Austrian Technical Position Paper

**Safety Aspects of
Temelín Nuclear Power Plant**

July 2001

6.8 Attachment 2: Arrangement of MSSV and BRU-A valves on steam-lines

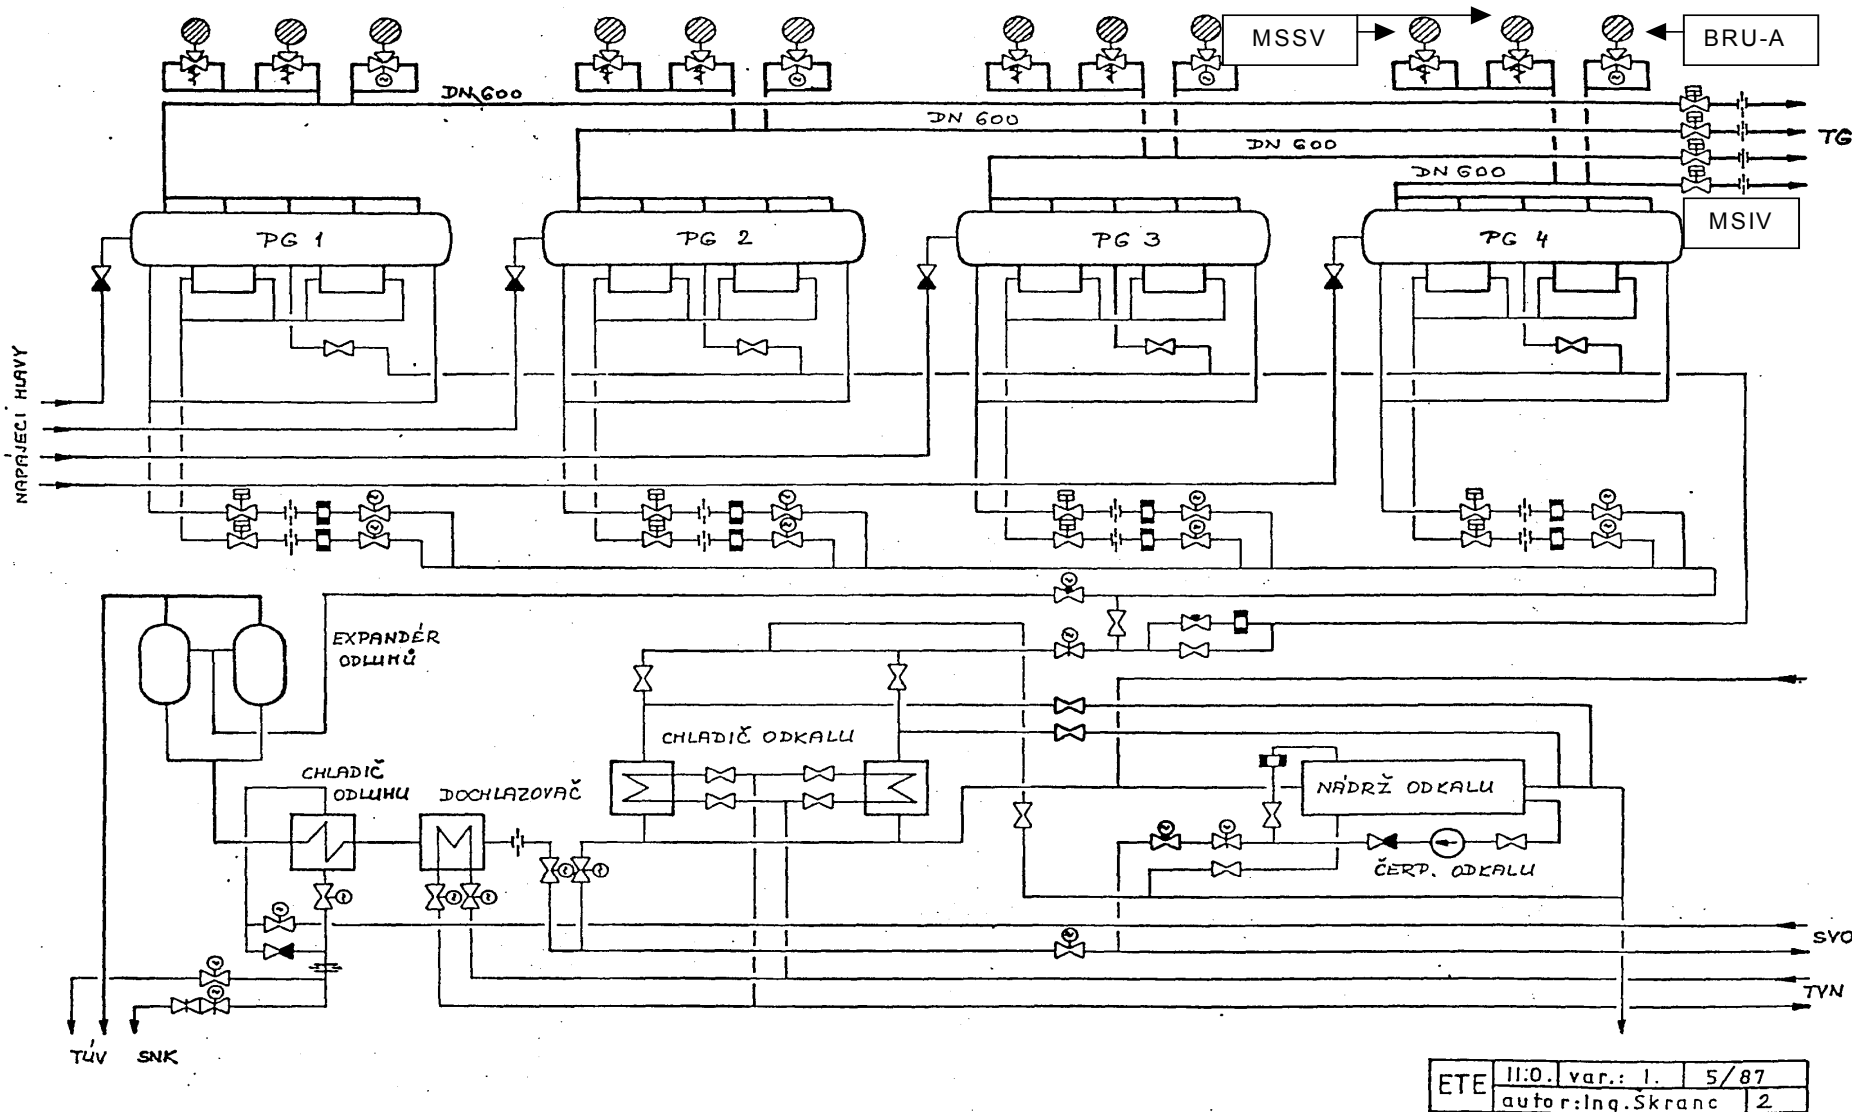
PRISE in WWER reactors (IAEA, 2000):

The IAEA document on PRISE in WWER reactors from 2000, states that at WWER reactors BRU-As and SGSV are originally qualified for steam flow only and not for water-steam mixtures. For such a qualification, it is likely (under SG overfill conditions) that once these valves open, they can remain fully or partially stuck open.
